Rezoning Application: PD 25-0274**Zoning Hearing Master Date:** June 16, 2025**BOCC Land Use Meeting Date:** August 12, 2025**Hillsborough
County Florida****Development Services Department****1.0 APPLICATION SUMMARY****Applicant:** KB Homes**FLU Category:** RES-4**Service Area:** Urban**Site Acreage:** 37.2**Community
Plan Area:** Seffner Mango**Overlay:** None**Introduction Summary:**

AGENCY REVIEW COMMENT SHEET

PETITION NO: PD 25-0274

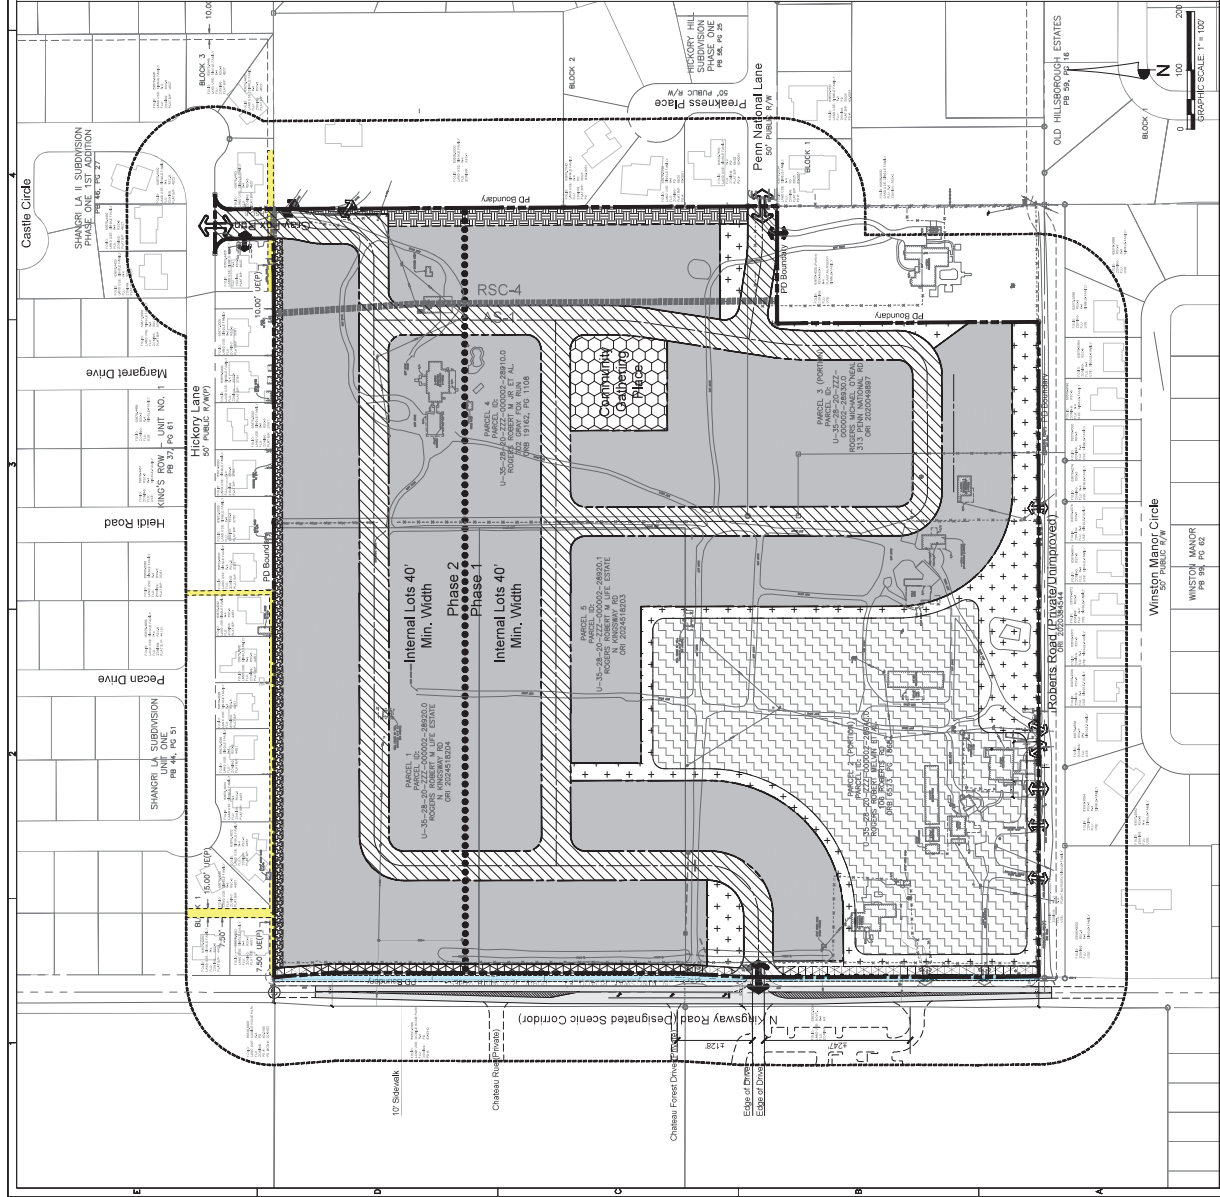
Prior to Certification, the applicant shall revise the General Notes #33 as follows: "Access to the east is proposed via Penn National Road. Access to the north is proposed via Gray Fox Run, which is proposed to become a public road." [Replace the words "cross access" with "access". Cross access is not the same as access and is not applicable to residential subdivisions.]

- Prior to Certification, the applicant shall revise the General Notes #33 as follows: “~~Cross access~~ Access to the east is proposed via Penn National Road. ~~Cross access~~ Access to the north is proposed via Gray Fox Run, which is proposed to become a public road.” [Cross access is not the same as access and is not applicable to residential subdivisions.]
